DEVELOPMENT REVIEW BOARD  
**SUPPLEMENTAL SUBMITTAL**

PROJECT NO. PR-2018-001579

SUBMITTAL DESCRIPTION: Based on the comments from the DRB Hearing January 5, 2022 we requested a deferral

**RE: PR-2018-001579 – WINROCK TOWN CENTER, SI-2021-00304 SITE PLAN, SI-2021-00305 SITE PLAN AMENDMENT, SUMMARY PLAT (PLAT OF EASEMENTS ONLY)**

PROJECT TITLE WINROCK TOWN CENTER 2100 LOUISIANA BLVD. N.E. ALBUQUERQUE, NEW MEXICO	JOB NO. WIN-PARK	DRAWN BY S
PROJECT MANAGER STEPHEN DUNBAR, AIA	SHEET TITLE PROPOSED ROAD-E	
DATE 01-14-22	sheet SP-1B	
SCALE RE: SCALE	of.

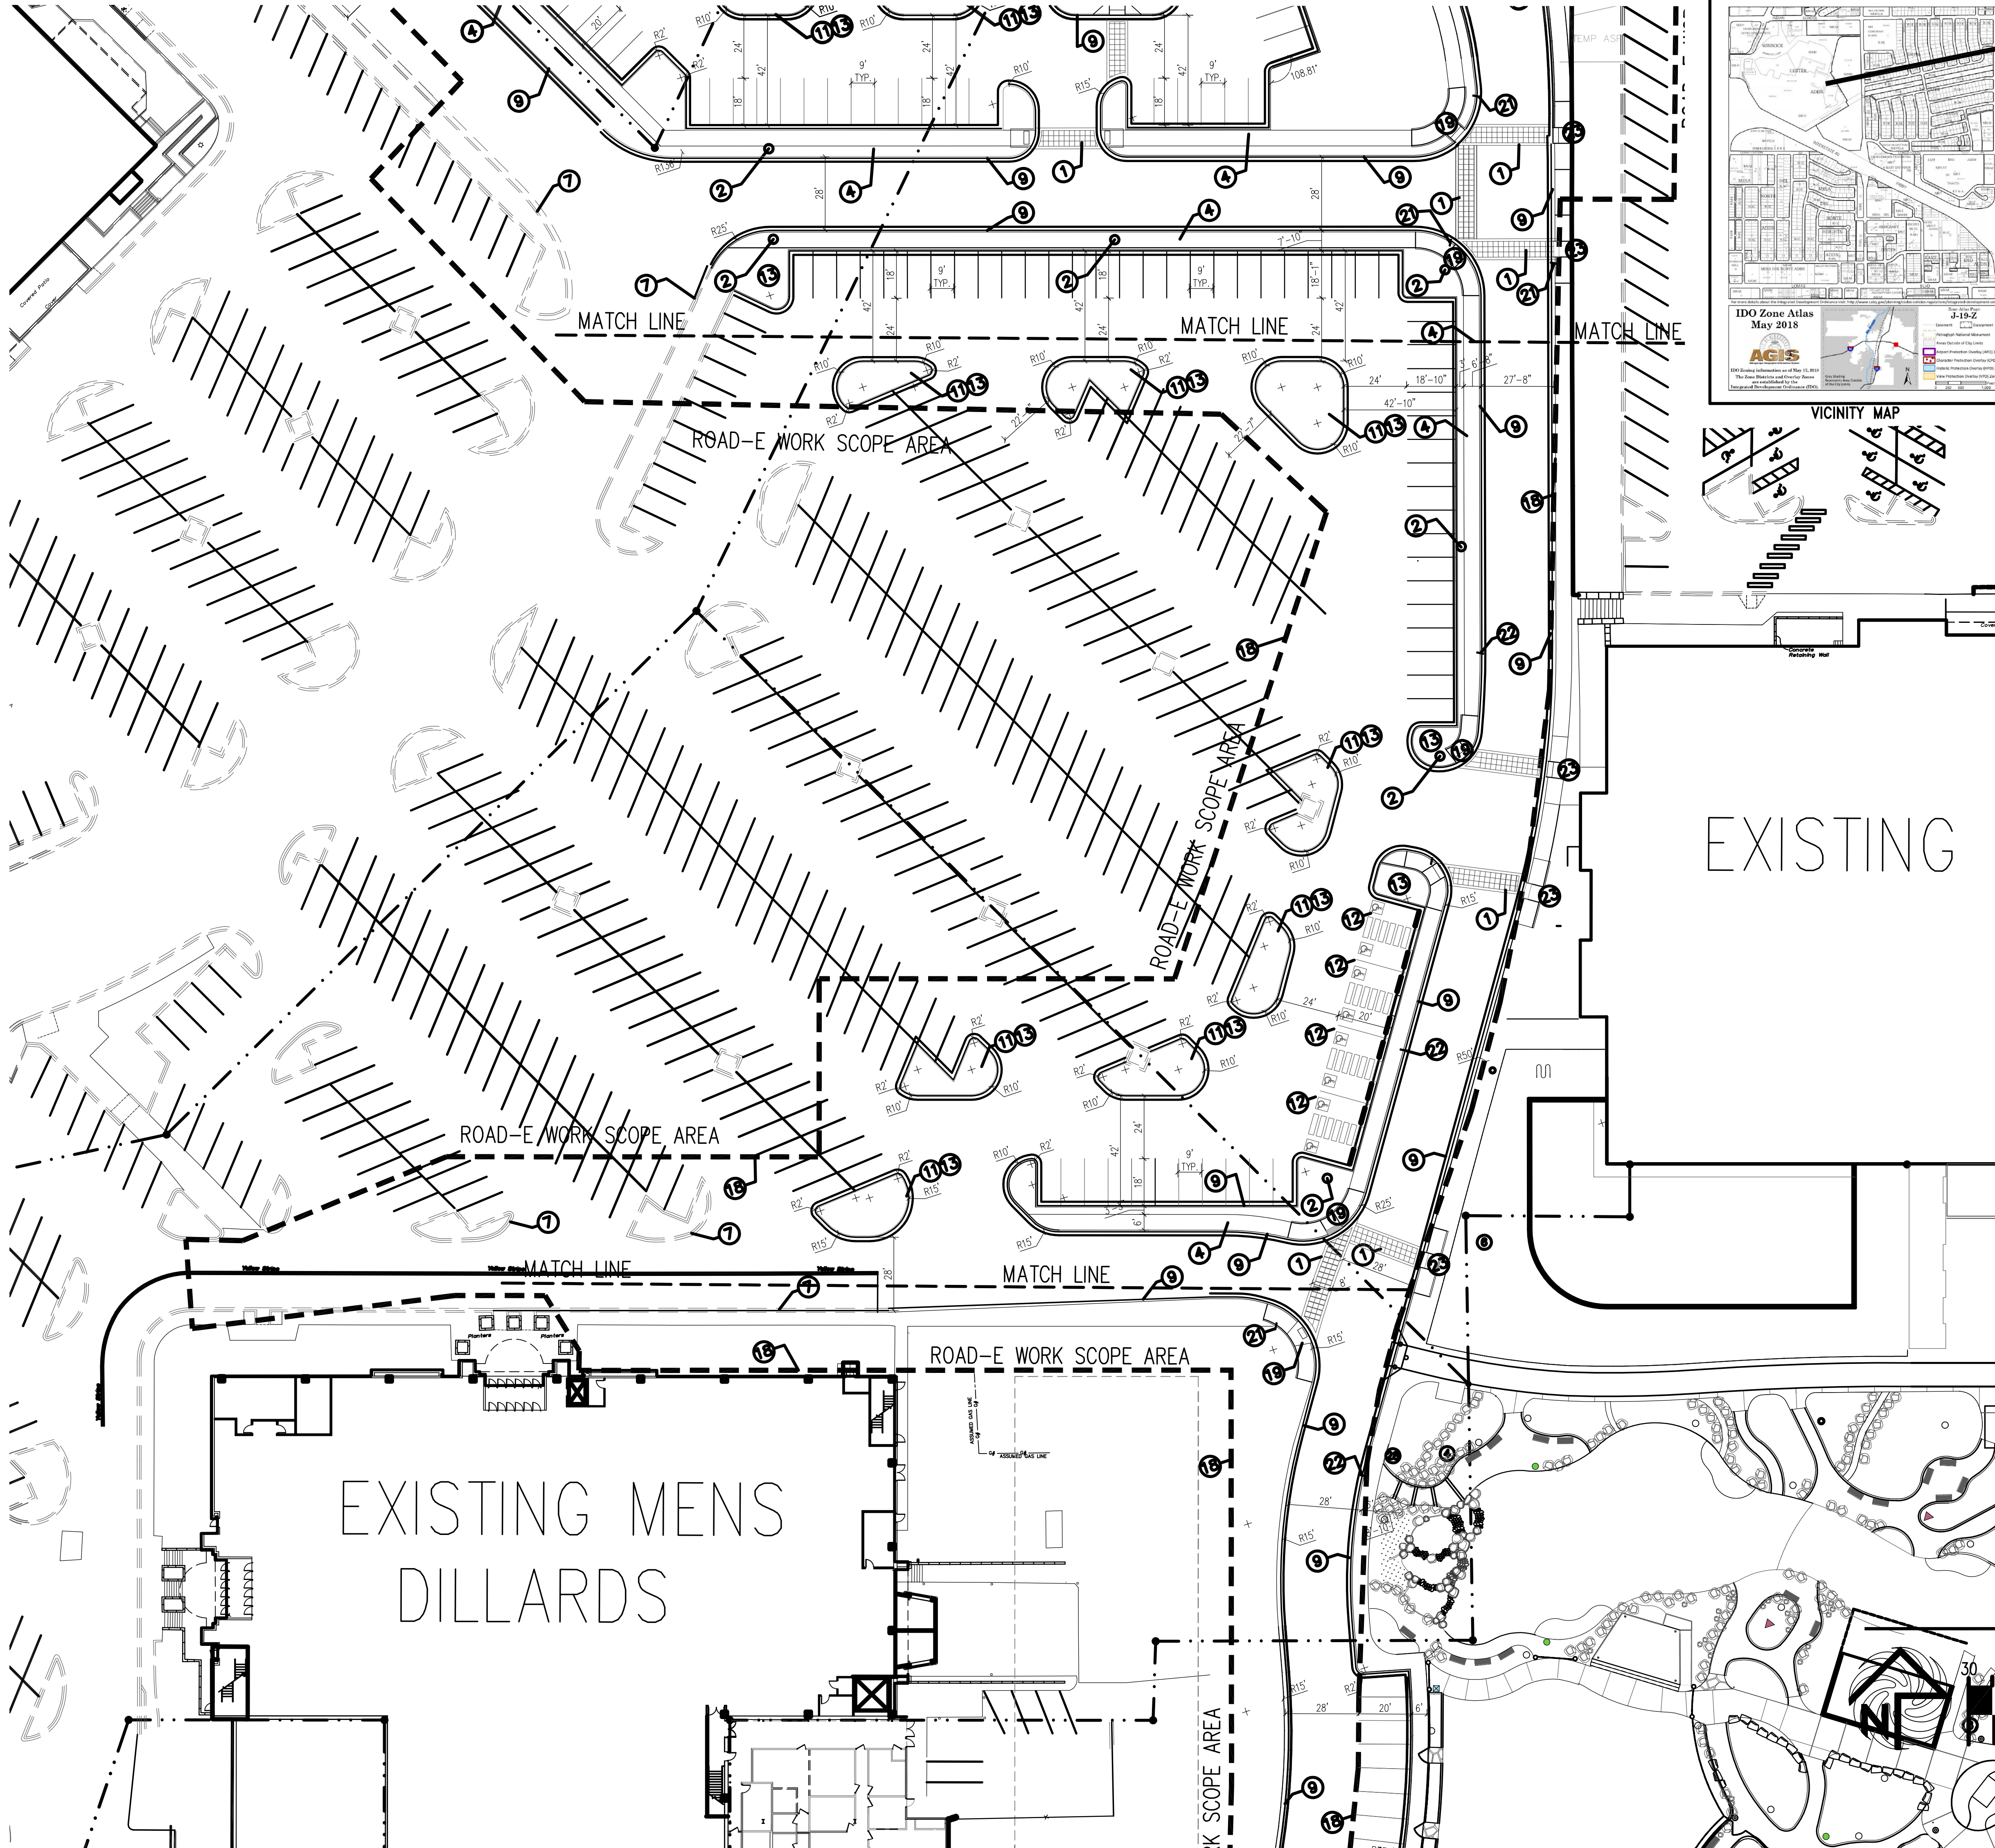
1. Stamp and sign drawings.
  - **Applicant Response: All drawings have been stamped and signed.**
2. Show cross-sections of Roadway E with cross-slopes, lane widths and sidewalks. Call out details for curb.

- **Applicant Response: City Project Number 538491 and plans have been submitted to DRC. Shown on work order plans per discussion with Jeanne .**
3. Label all handicapped signage and motorcycle parking signage on the plan.

PROJECT TITLE: WINROCK TOWN CENTER  
 2100 LOUISIANA BLVD.  
 JOB NO.:  
 DRAWN BY:  
 PROJECT MANAGER:  
 SHEET TITLE: CONCEPTUAL SITE UTILITY PLAN

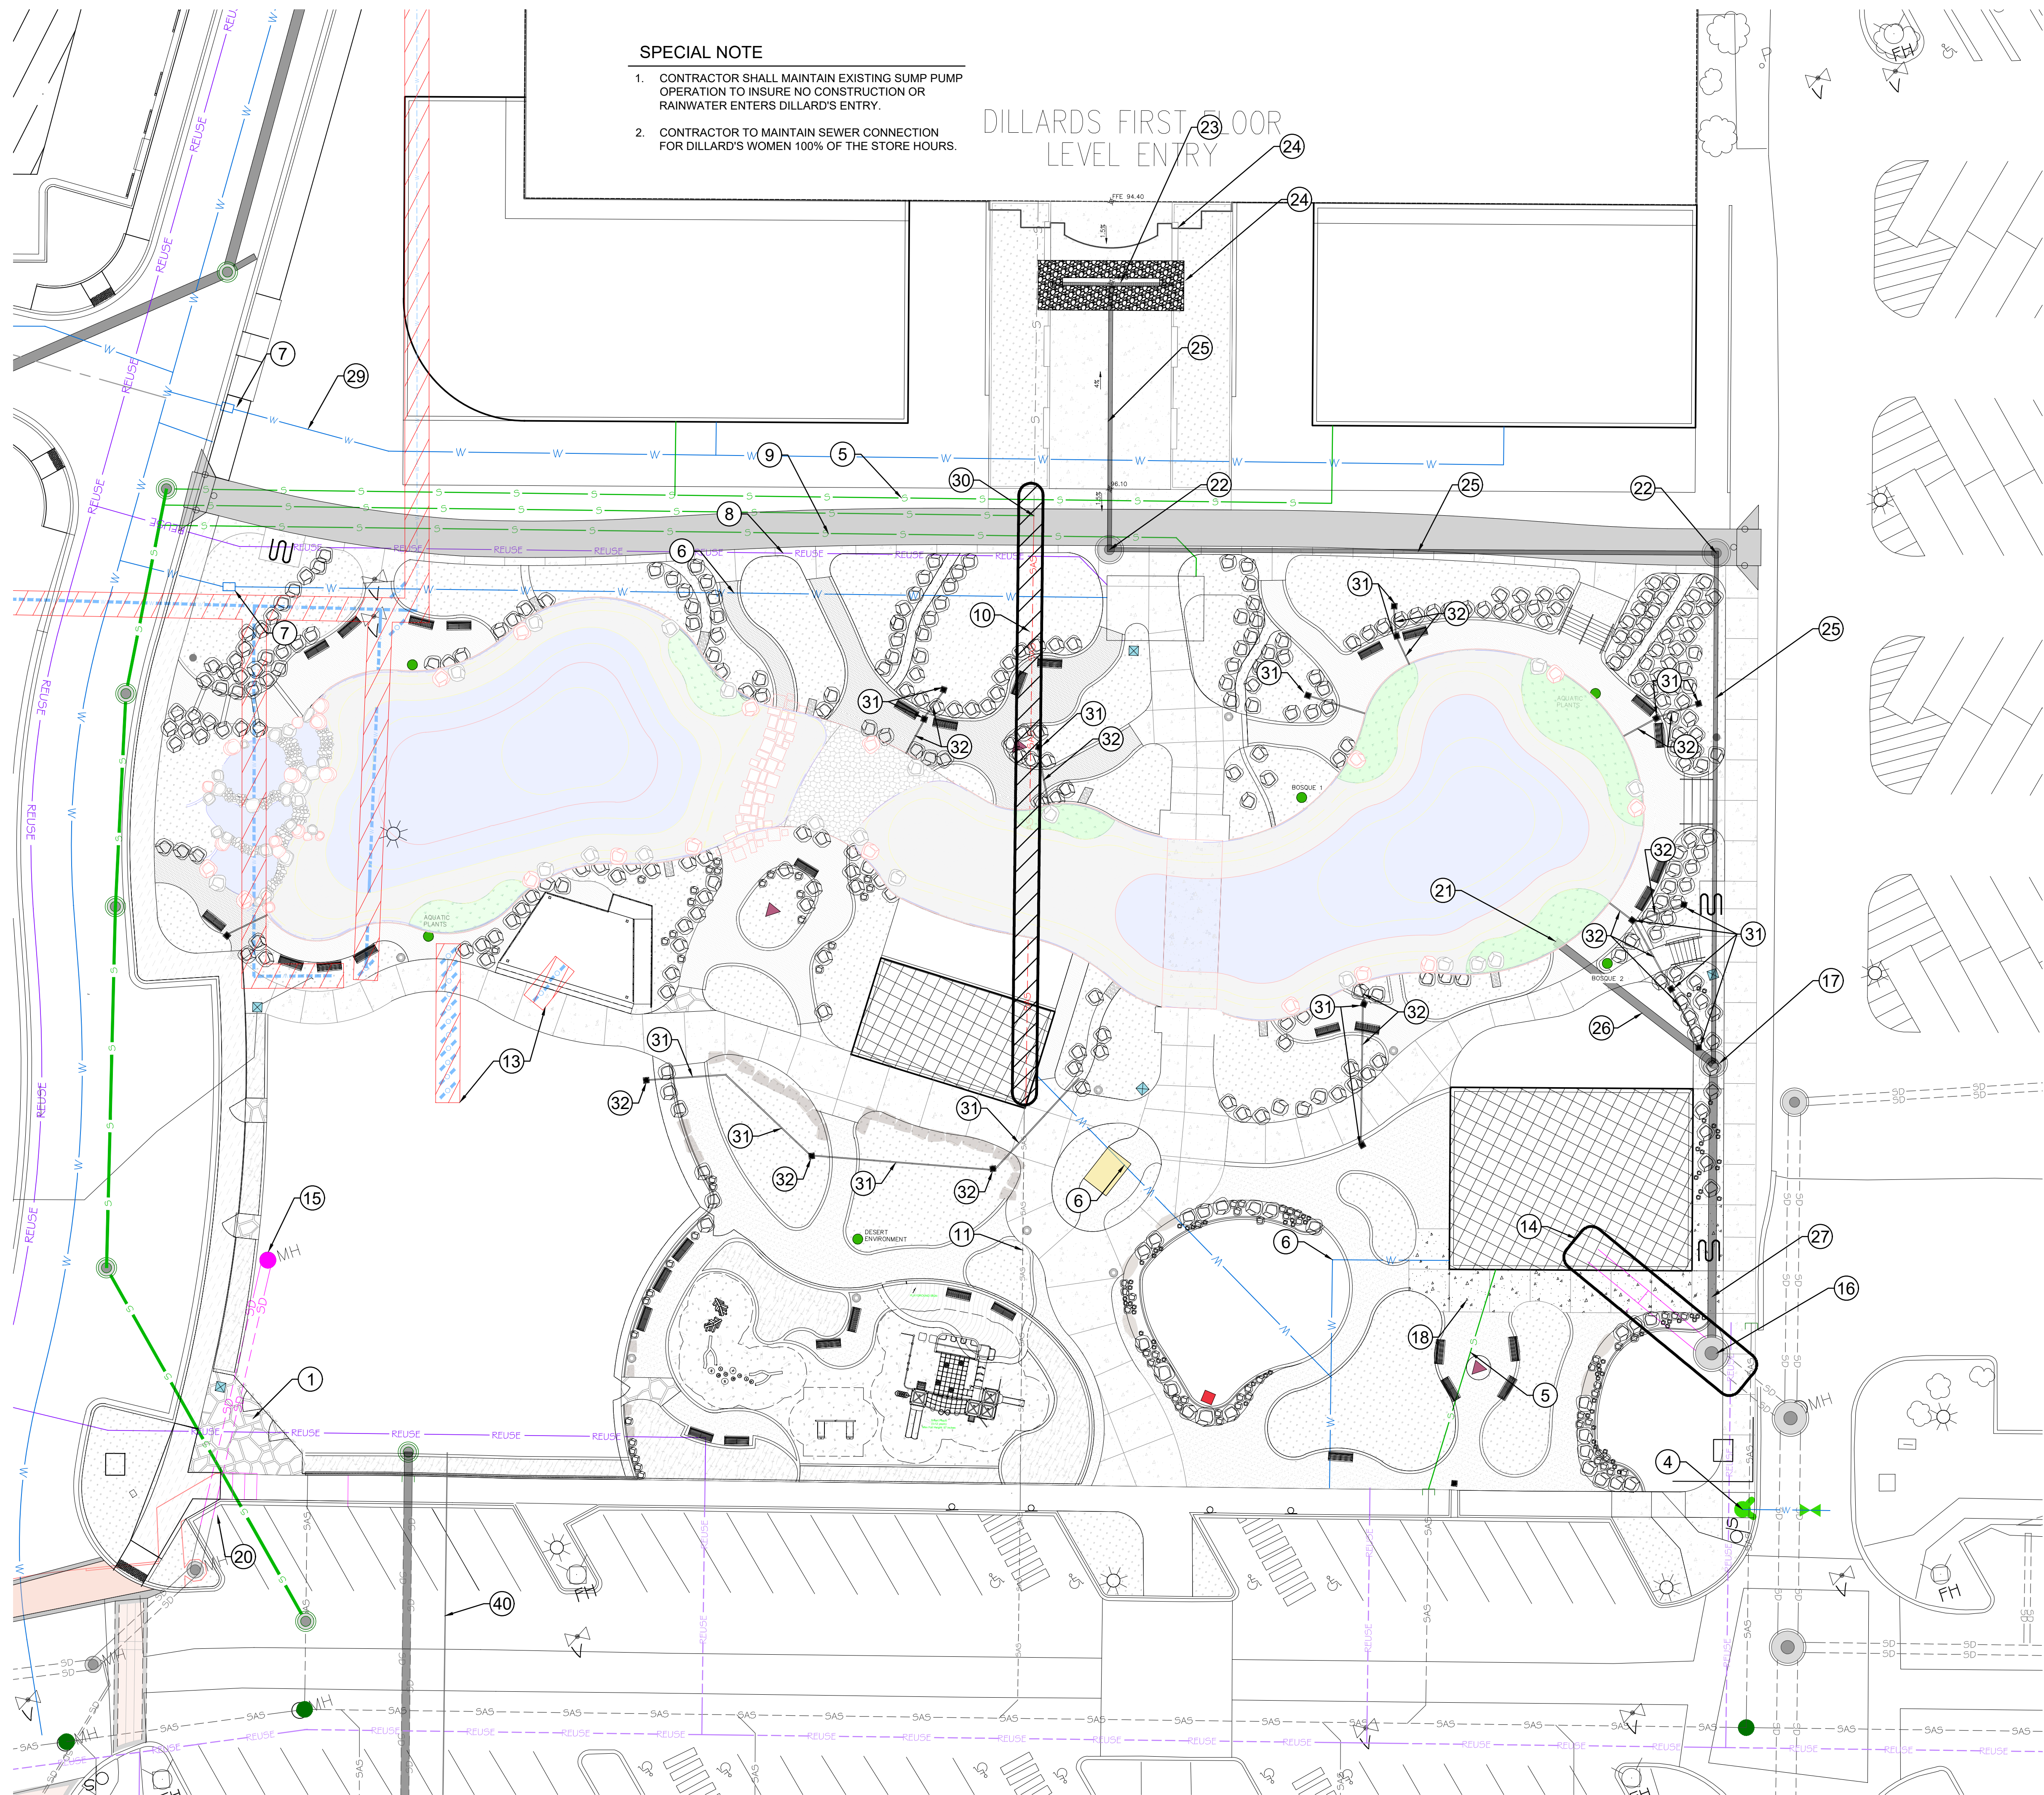
i. Please label the Roads listed in the water/sewer callouts on the utility plan.

**1. Applicant Response: Infrastructure list has been updated.**

PROJECT TITLE WINROCK TOWN CENTER 2100 LOUISIANA BLVD.	JOB NO. DRAWN BY:
PROJECT NUMBER	SHEET TITLE APPLICABLE EASEMENTS

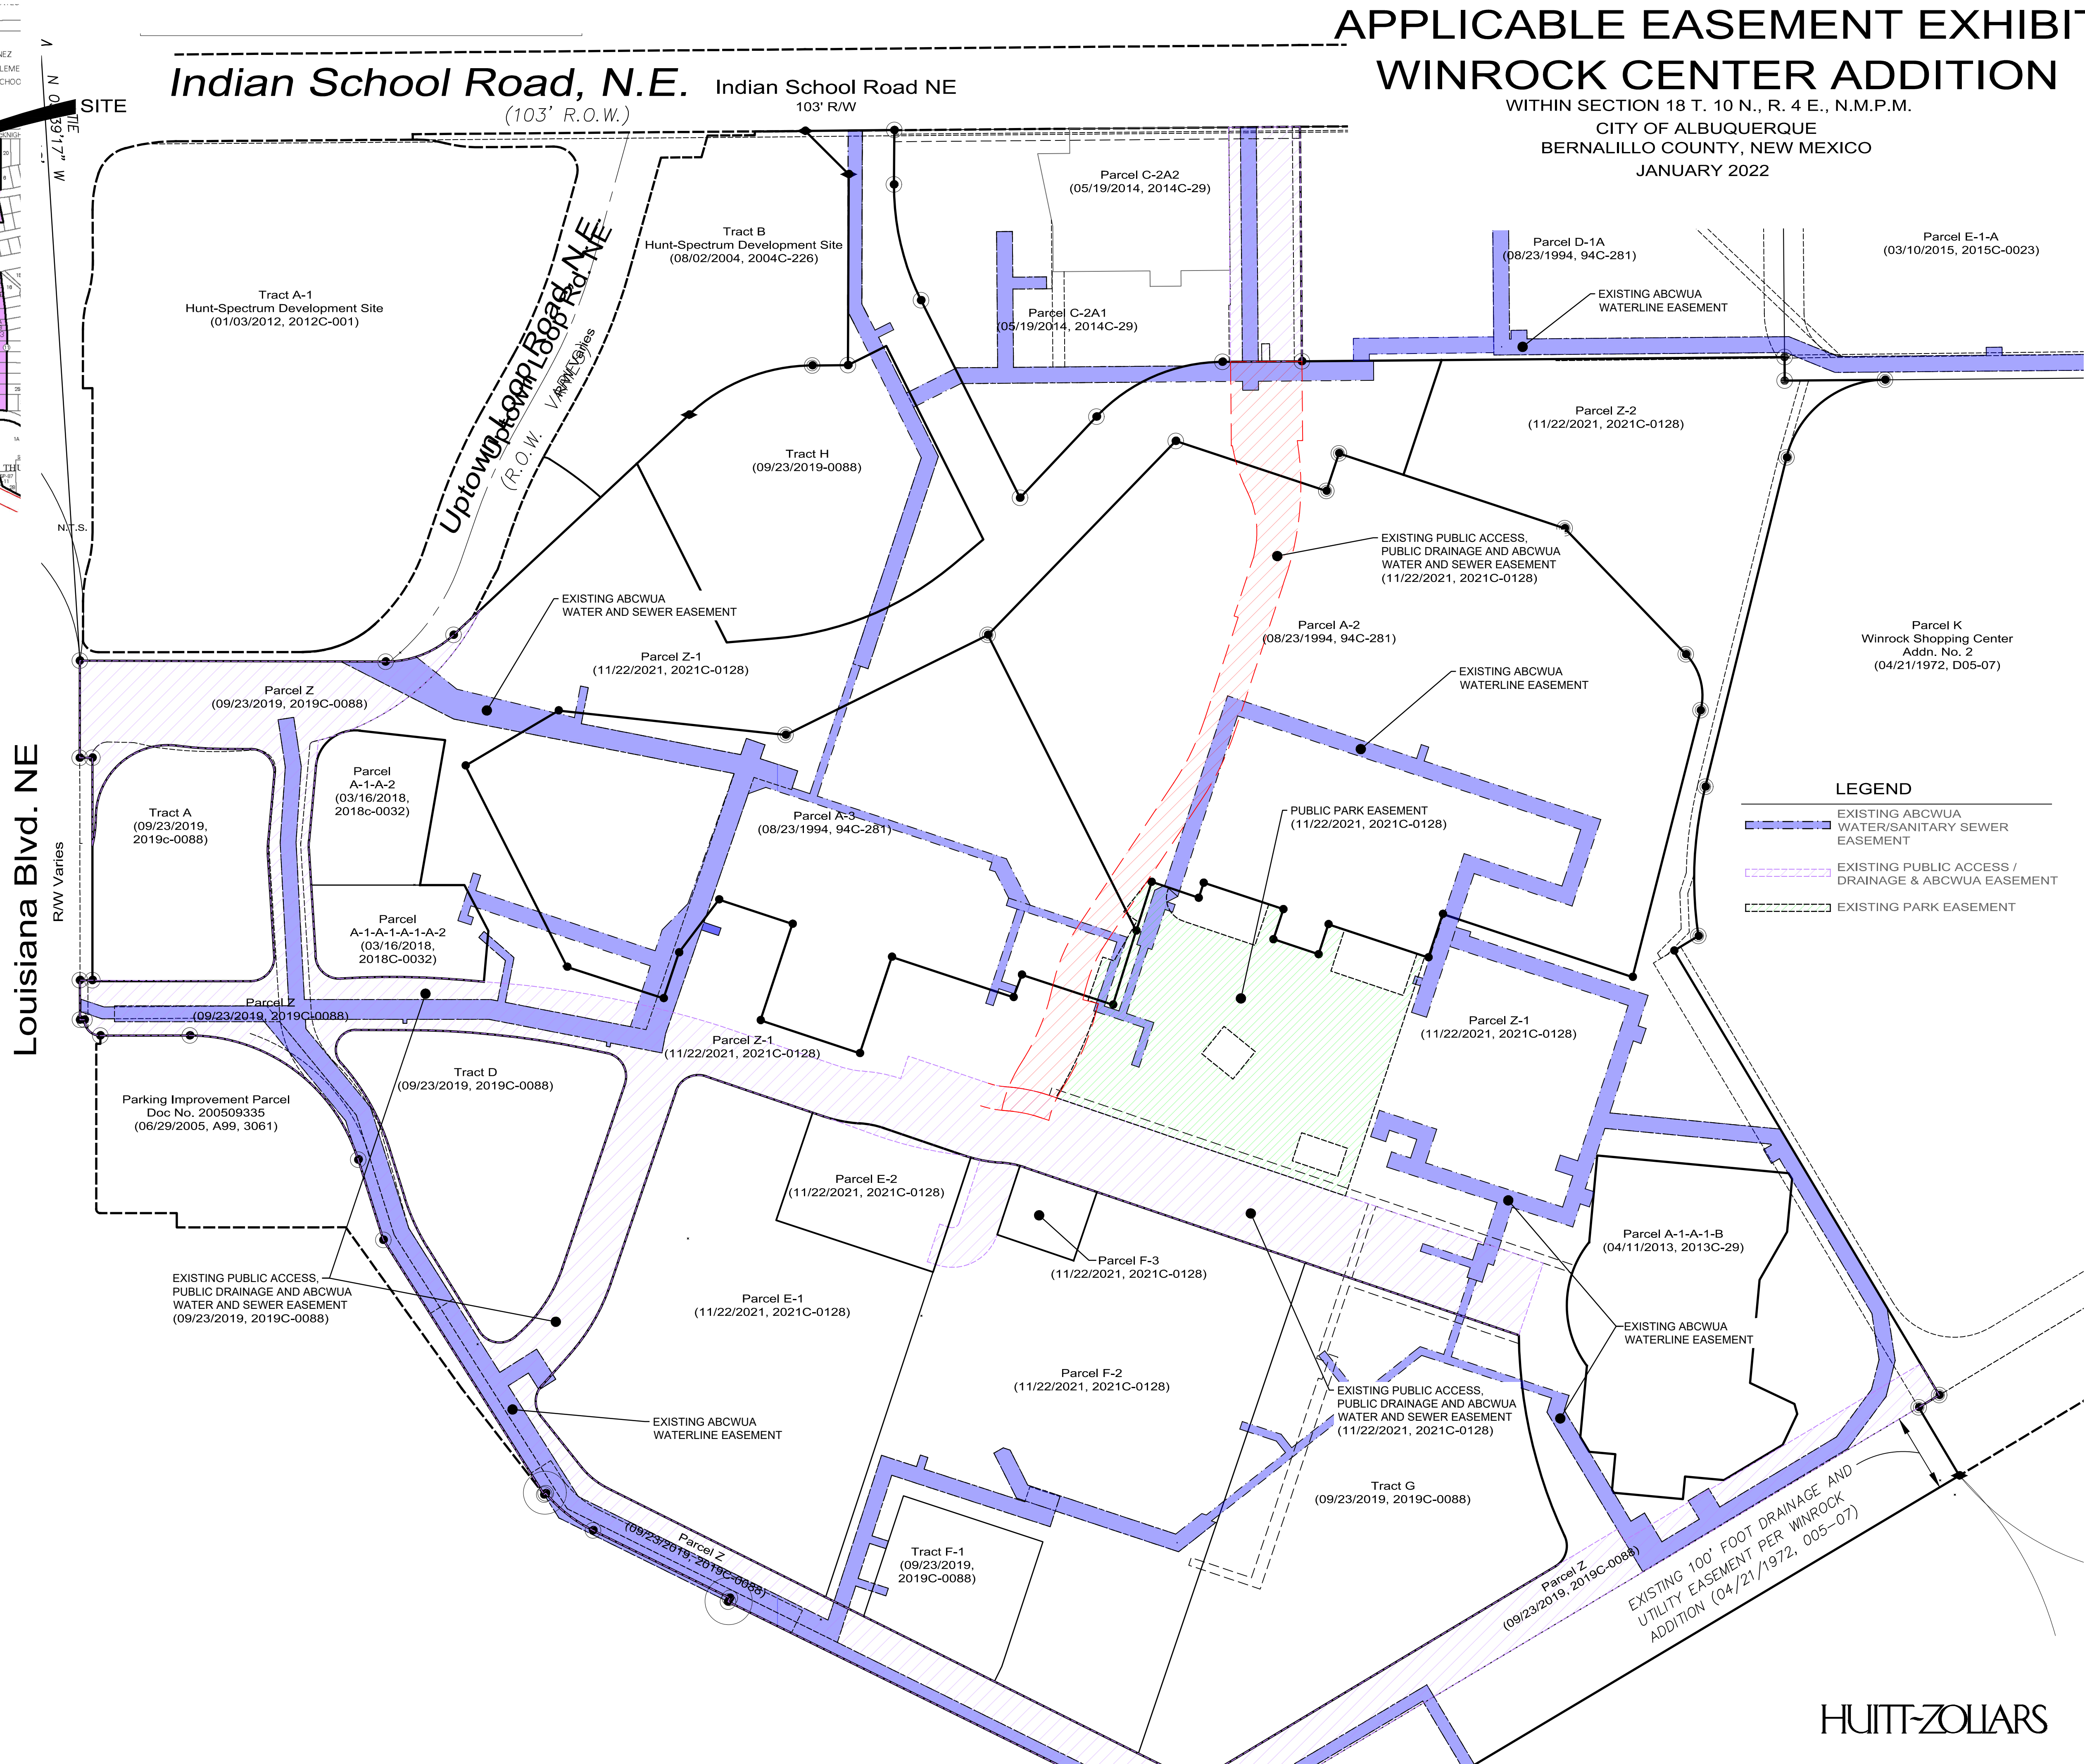
iv. PREVIOUS COMMENT: Please demonstrate sufficient easements for the proposed reuse lines, and any other public water and public sewer lines not currently within easements. The easement map provided with the plat does not appear to show easements for all the public lines, in particular the reuse running through the park and the initial sewer connection to existing manhole.

**1. Applicant Response: Easement Ex. Added.**
